Customs Convention on the International Transport of Goods under Cover of TIR Carnets (TIR Convention, 1975) –

Amendment proposals to the Convention: Vehicles with sliding sheets

Vehicles and containers with sliding sheets

Submitted by the International Association of the Body and Trailer Building Industry

Sketch No. 9.4

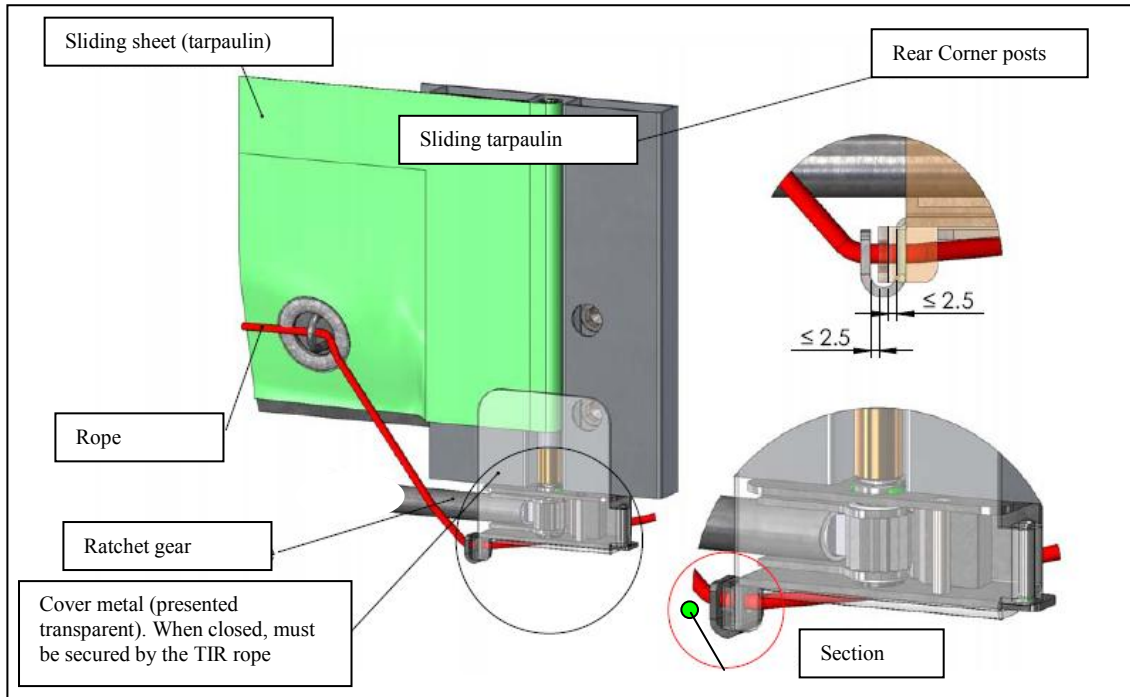
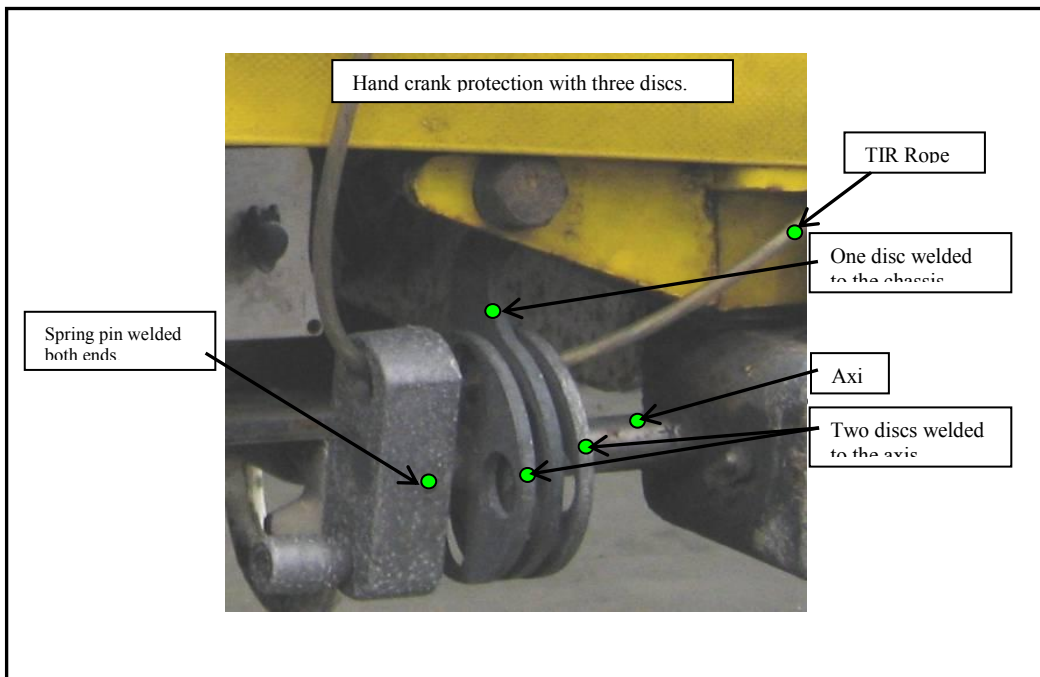
6. Amend Sketch No. 9 as follows:

To tighten the sliding sheets in the horizontal direction, a ratchet gear is used (normally on the rear end of the vehicle). This sketch shows two examples (a) and (b) how the ratchet or gearbox may be secured.

Sketch No. 9.5

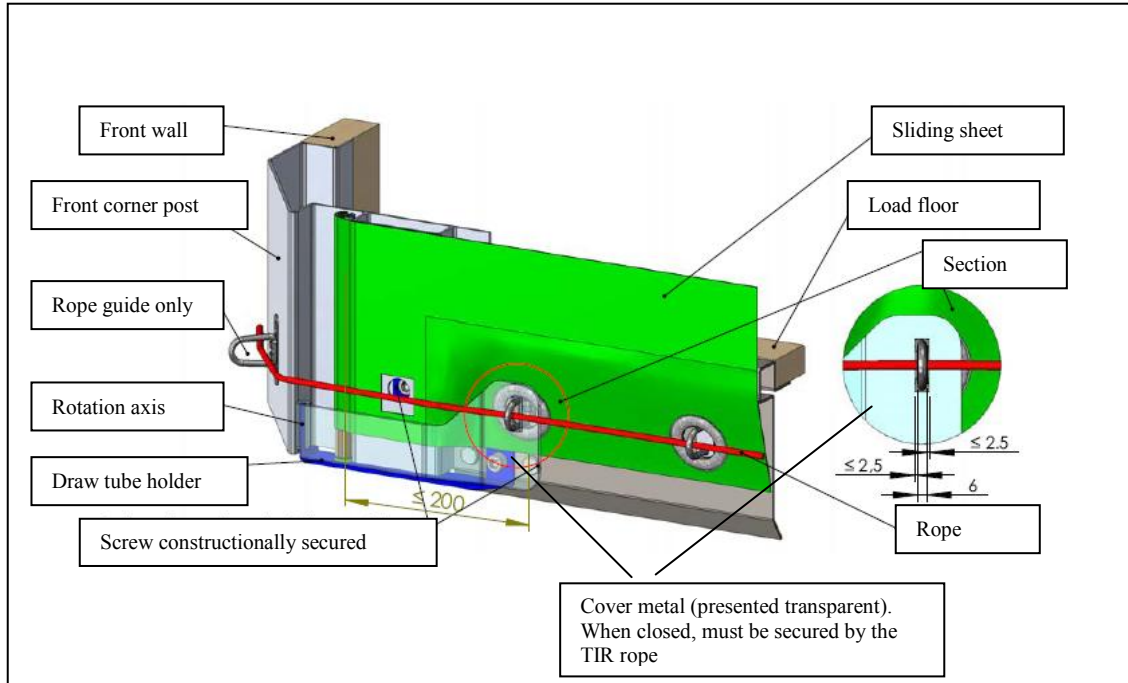
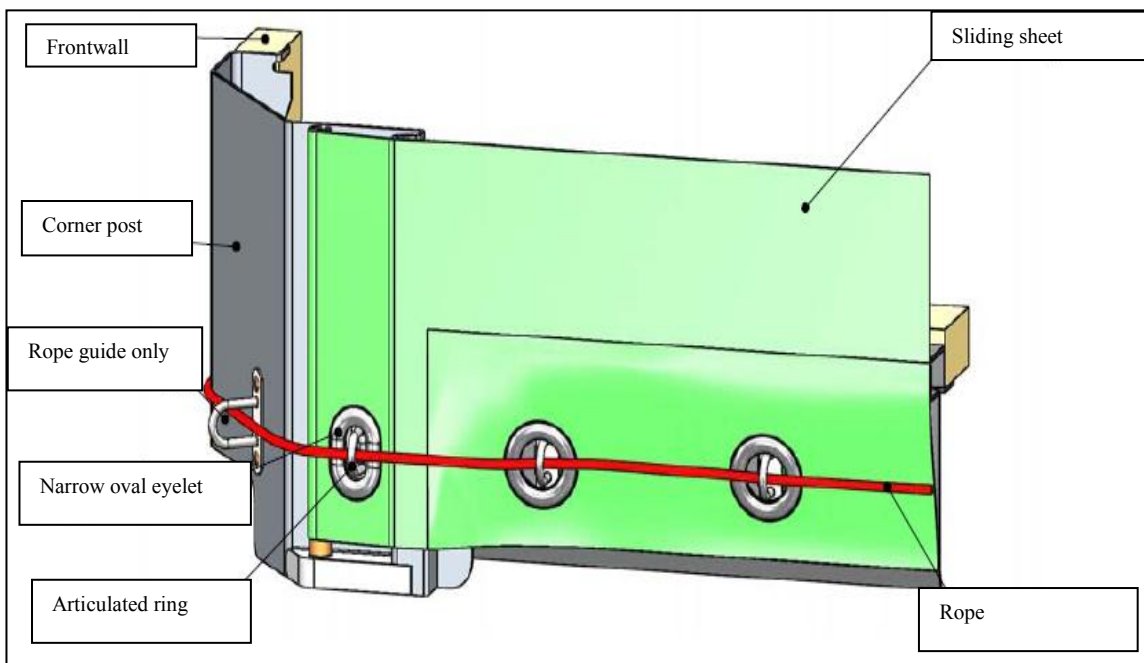
To fix the tarpaulin on the other side (normally to the front of the vehicle) the following systems (a) or (b) may be used.

Sketch No. 10

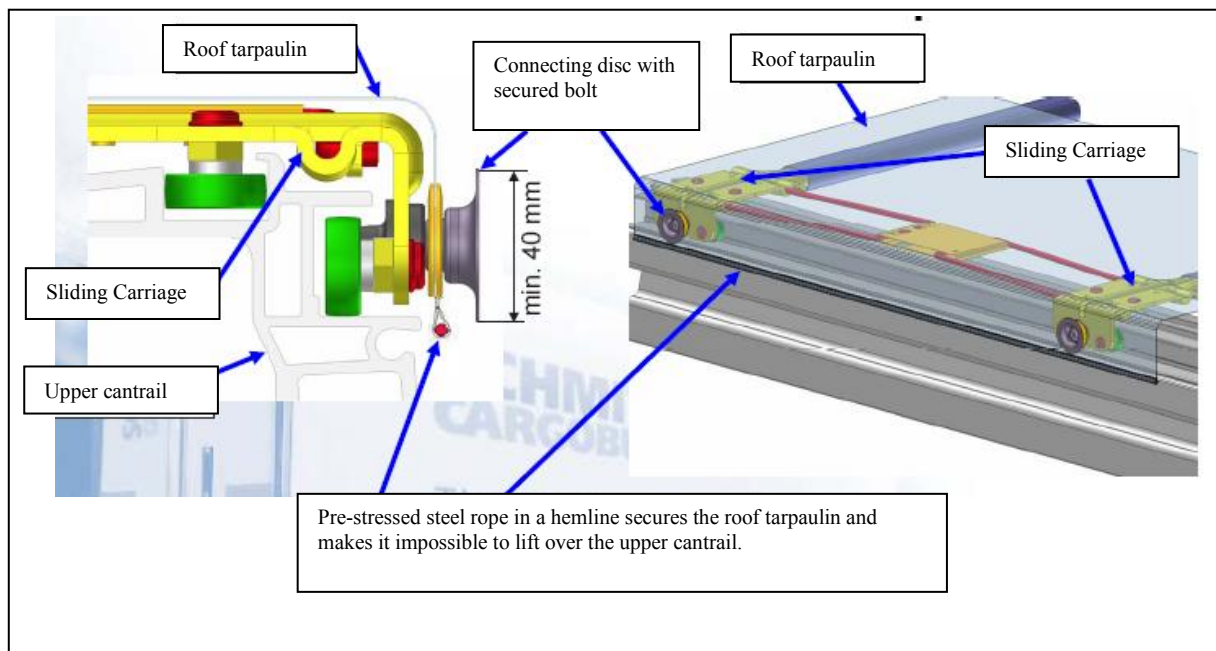
7. After Sketch No. 9, add a new Sketch No. 10:

This sketch shows an example of a vehicle and of important points described within Annex 2, Article 5.

The Customs security of the sliding roof is guaranteed if a pre-stressed steel rope, embedded in a hemline, is fixed. This steel rope is fixed to the front and rear of the body. The tractive force as well as the connecting disc on each sliding carriage, makes it impossible to lift up the hemline with the steel rope above the upper cantrail.

Sketch No. 9.4

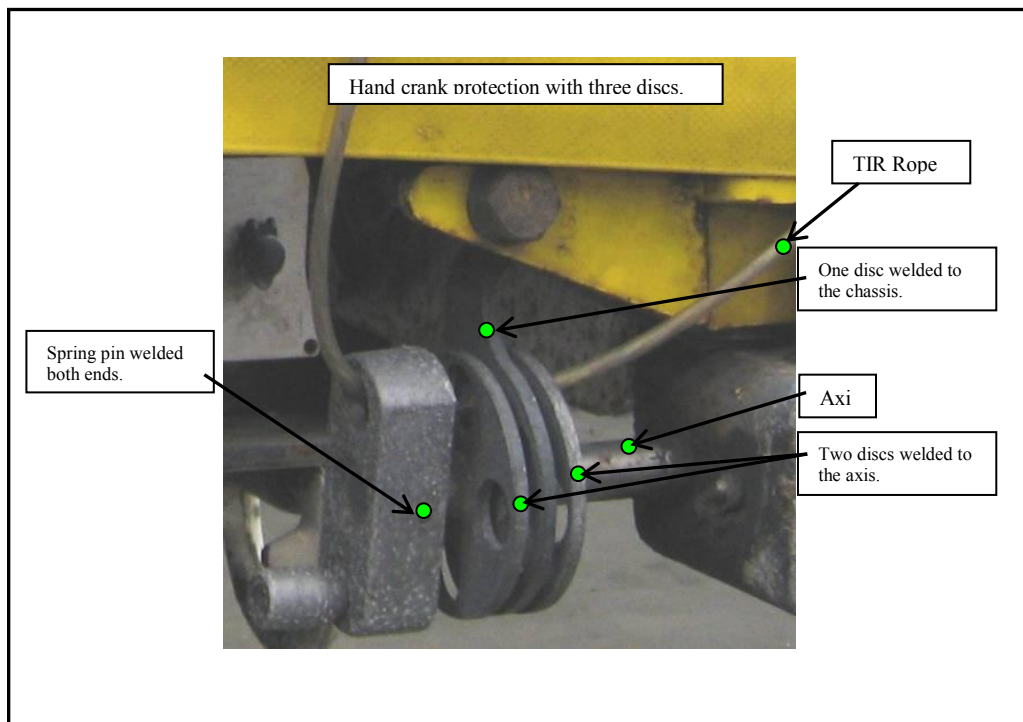
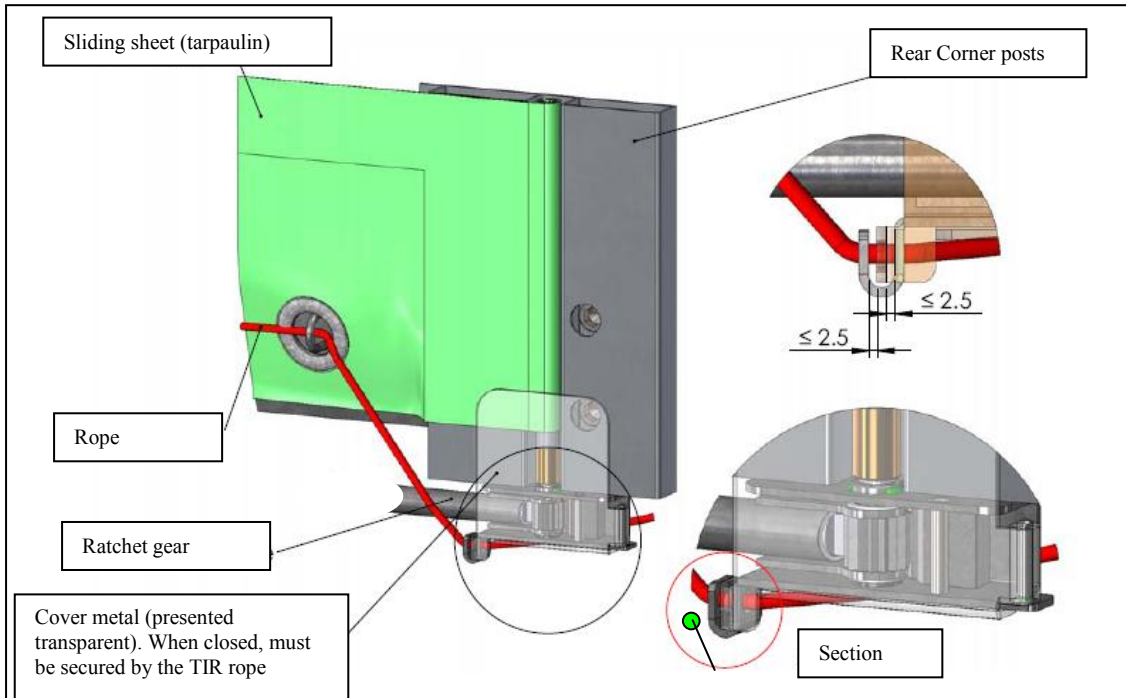
11. Amend Sketch No. 9 to Annex 7 – Part I,

To tighten the sliding sheets in the horizontal direction, a ratchet gear is used (normally on the rear end of the container). This sketch shows two examples (a) and (b) of how the ratchet or gearbox may be secured.

Sketch No. 9.5

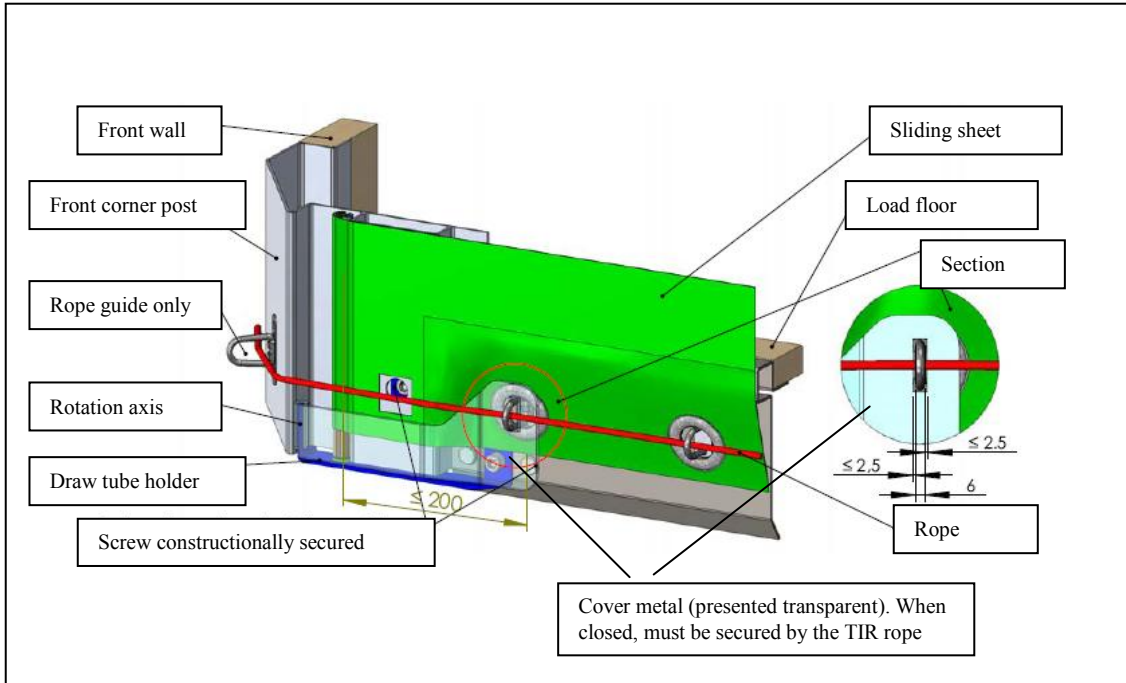
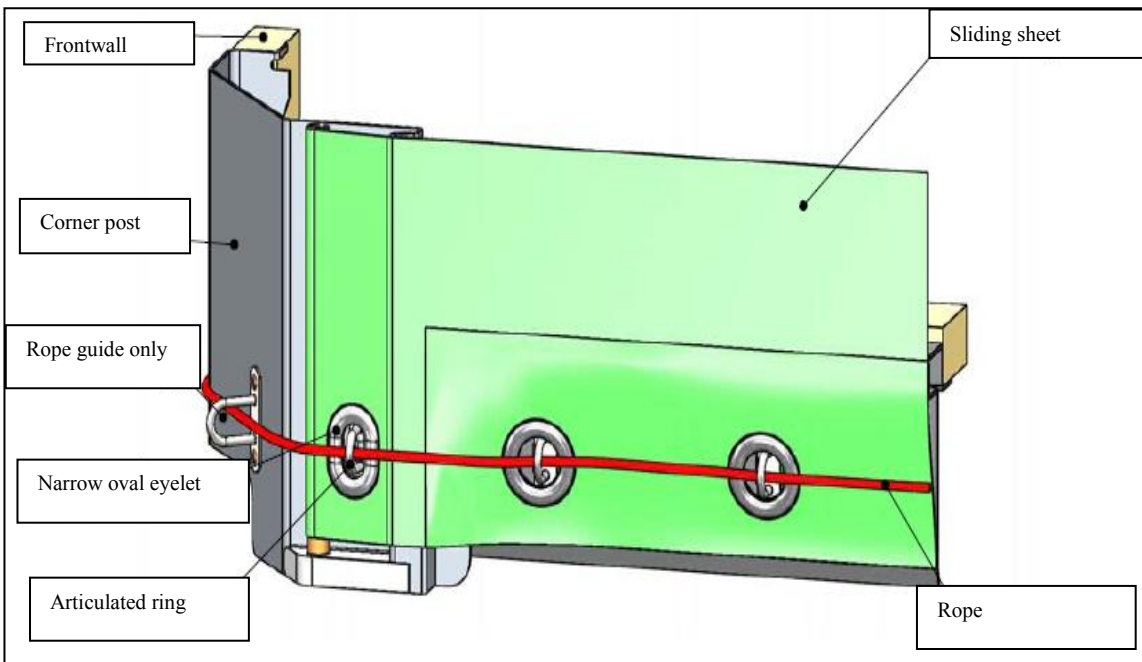
To fix the tarpaulin on the other side (normally to the front of the container) the following systems (a) or (b) may be used.

Sketch No. 10

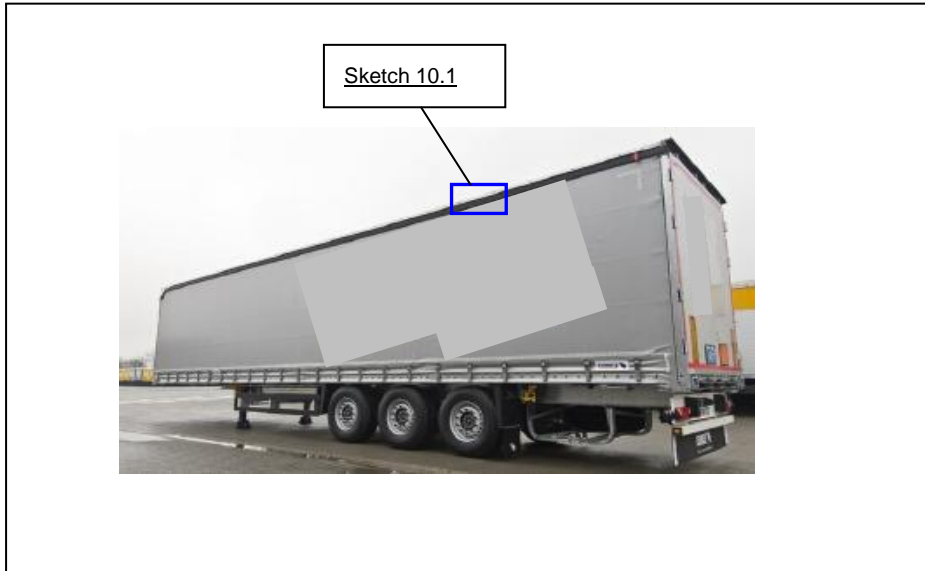
12. After Sketch No. 9 add a new Sketch No. 10:

This sketch shows an example of a container and of important points described within Annex 7, Part I, Article 6.

Sketch No. 10.1

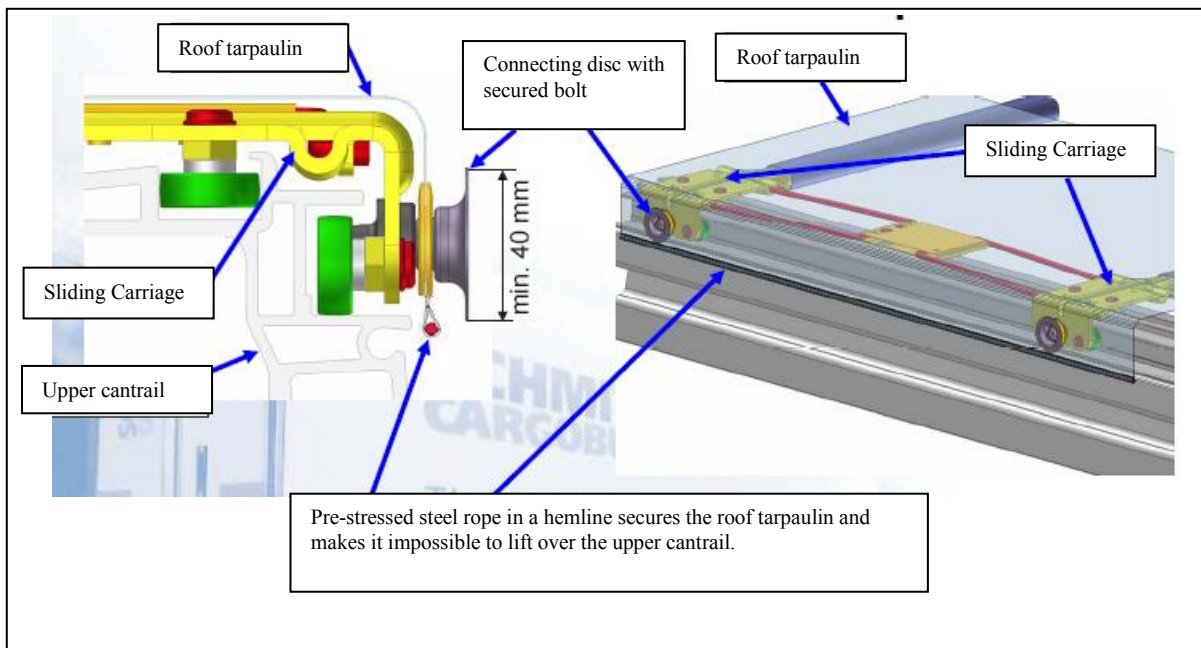
The Customs security of the sliding roof is guaranteed if a pre-stressed steel rope, embedded in a hemline, is fixed. This steel rope is fixed to the front and rear of the container. The tractive force as well as the connecting disc on each sliding carriage, makes it impossible to lift up the hemline with the steel rope above the upper cantrail.
